Service Letter No. 415

SUBJECT: Sealing of the Nose Wheel Well

MODELS AFFECTED: PA-30 Twin Comanches, Serials 30-1 to 30-205 inclusive

**Service letter No. 415**

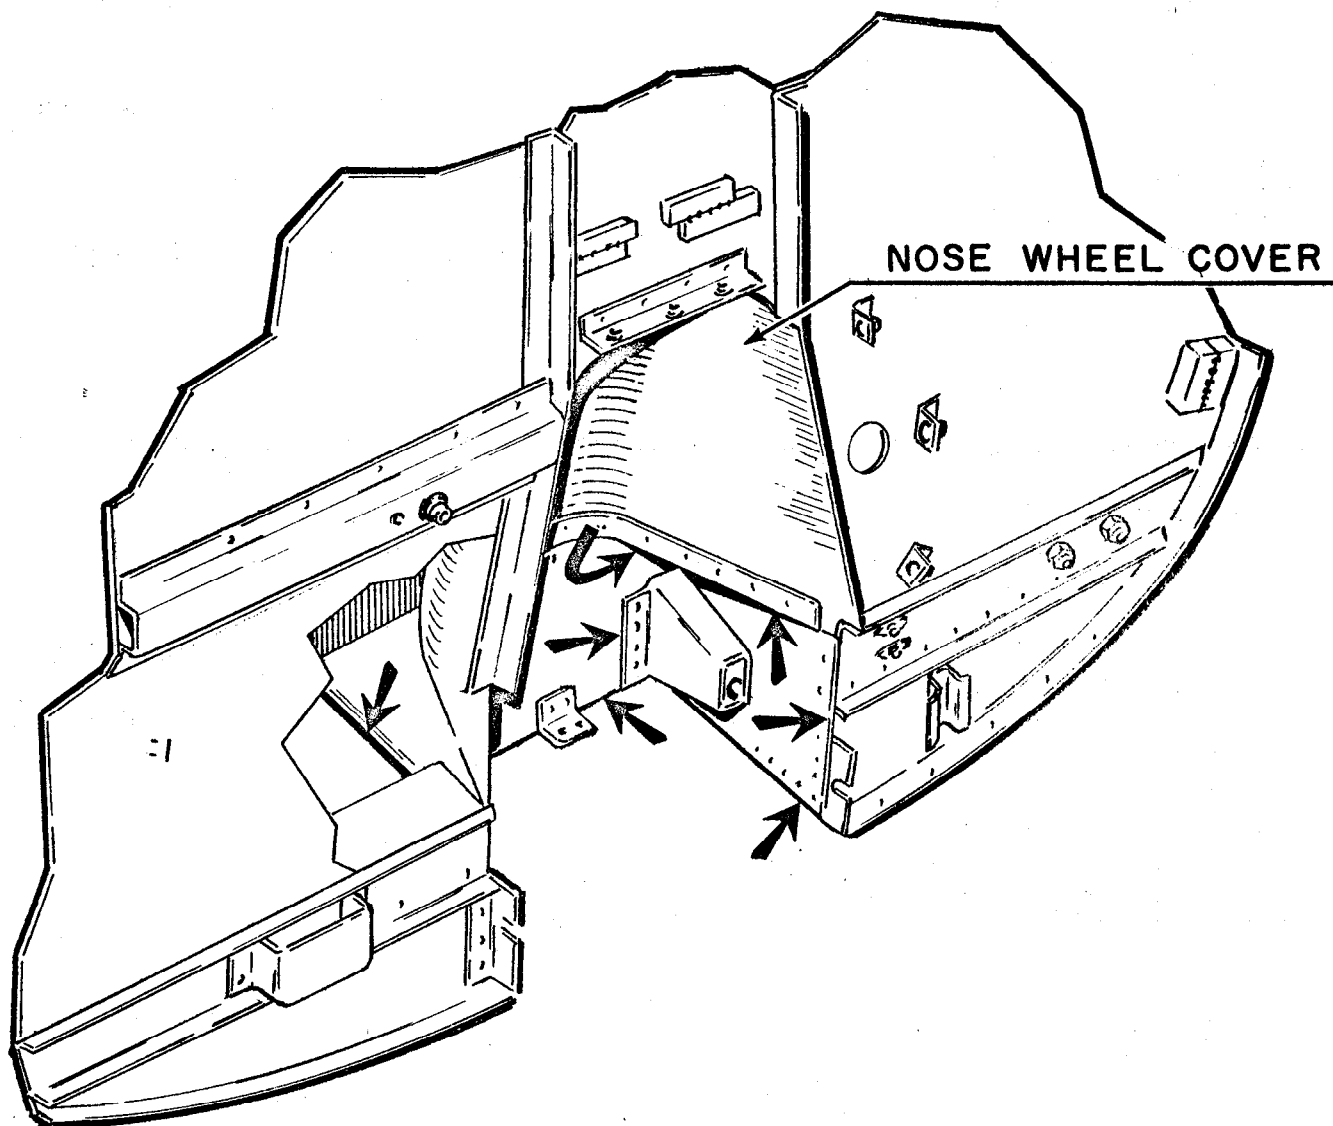
Reports have been received of moisture entering the fuselage area occupied by the circuit breakers causing the circuit breakers to trip.

To eliminate this problem, additional sealing of the seams in the nose wheel well will be necessary in those aircraft indicated by the serial numbers listed above. Permagum Bead #576 and shellac or an equivalent method of sealing should be used. Please refer to sketch on the reverse side of this letter which indicates the areas affected.

➔ SEAL THESE JOINTS WITH PERMAGUM BEAD # 576 & SHELLAC OR EQUIVALENT.
